# **A G E N D A**

## **Architectural Review Board**

**September 22, 2015**

*1308 S. McDonough Street*

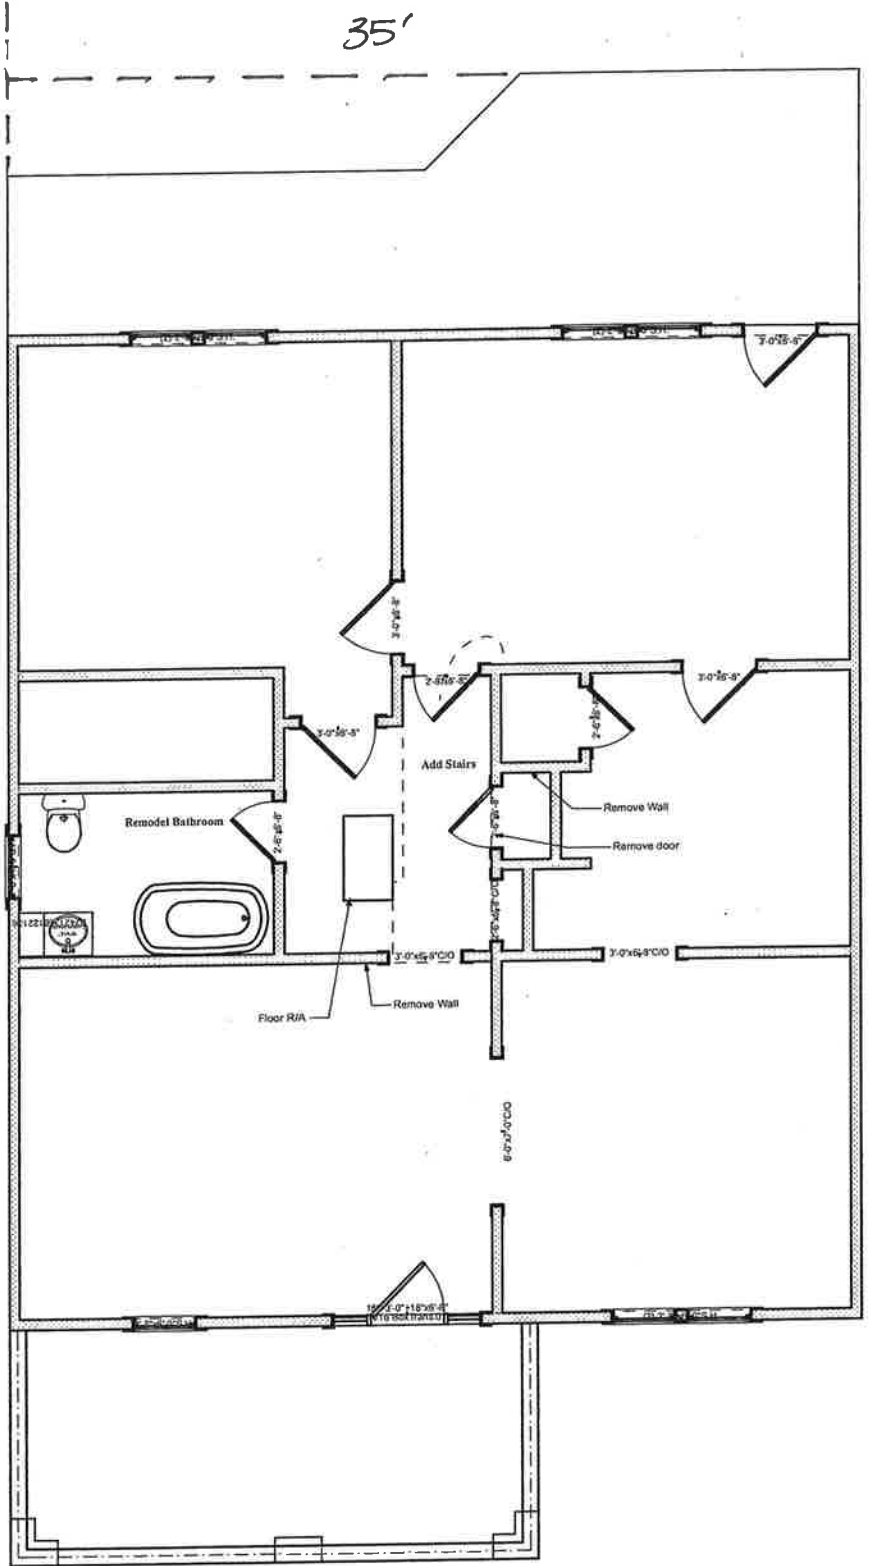
- No objection.
